গণপ্রজাতন্ত্রী বাংলাদেশ সরকার
শ্রম ও কর্মসংস্থান মন্ত্রণালয়
কলকারখানা ও প্রতিষ্ঠান পরিদর্শন অধিদপ্তর

ক্যাপ পর্যবেক্ষণের তথ্য

কারখানার নাম	আইসিয়ার ক্যাশনস লিমিটেড		
ঠিকানা	55, SHOVPUR, RAJFULBARIA, SAVAR, DHAKA		
কারখানার কোড	DHK028		
কালার কোড

মূল্যায়নের ধরণ: বৈদ্যুতিক মূল্যায়ন	পর্যবেক্ষণের তারিখ: ০৯-০৪-২০২৩
১. পর্যবেক্ষণ

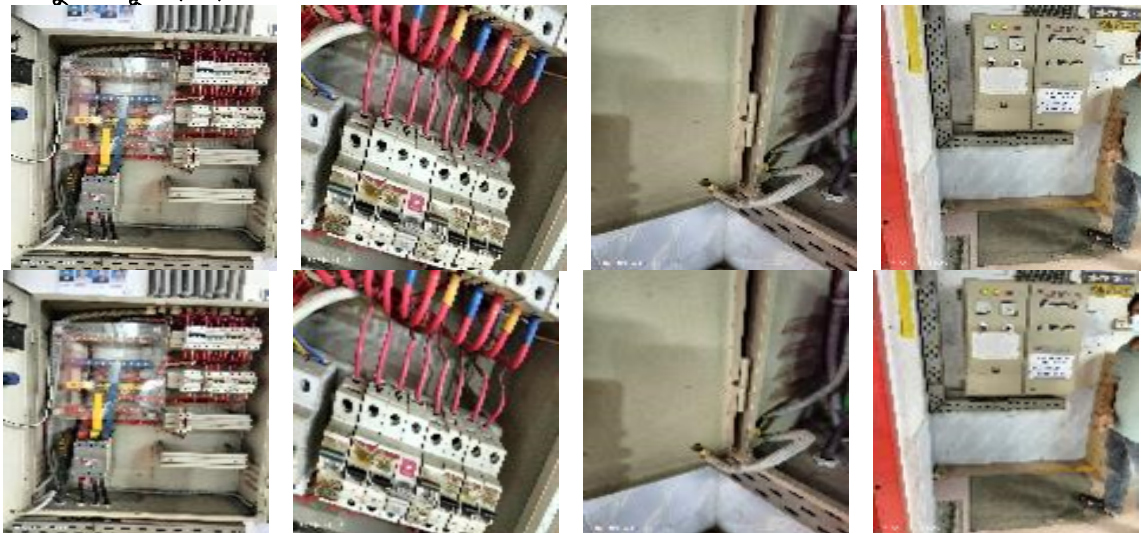
পরিদর্শন পর্যবেক্ষণ	Cable ends not properly or crimped □ Connection without lug □ Undressed messy wire inside □ Door not earthed □ No clear identification mark on distribution board □ Loose Circuit Breaker
ক্যাপ আইটেম ক্যাটাগরি

কার্যক্রম	Repair loose MCB. □ Provide earthing to body & door. □ Provide clear identification mark on distribution board.
সুপারিশের তথ্যসূত্র	
কারখানার কার্যক্রম	We have taken initiative & it will be completed within timeline.
অগ্রাধিকার	৬ সপ্তাহ
চূড়ান্ত সময়সীমা	-
সংশোধিত সময়সীমা	০১-০১-১৯৭০
অগ্রগতির অবস্থা	চলমান
মন্তব্য	Previous timeline: NA, during cap explanation (CAP01) factory claimed completed Final Timeline: 11/8/2017 ,Factory has taken action and they have agreed to implement within final timeline. 02-09-2020 Visit Observation: No clear identification mark on few distribution board. 01.12.2020 (CVV) : 1. Earthing connection is provided in body and door of distribution panels. 2. Distribution boards have clear identification mark. 28-03-2021 Visit Observation: 1. Earthing connection is provided in body and door of distribution panels. 2. Distribution boards have clear identification mark. 28-08-2021: 1. Earthing connection is provided in body and door of distribution panels. 2. Distribution boards have clear identification mark. 23-08-2022 : 1. Cable ends are properly or crimped. 2. Connection without lug. 3. Undressed messy wire inside. 4. Door earthed. 5. No clear identification mark on distribution board. 6. No Loose Circuit Breaker. 09-04-2023 : 1.Connection without lugs was found. 2.No undressed messy wire was found. 3.Door earthed was found. 4.Clear identification mark on distribution board was found. 5. No loose circuit breaker was found.
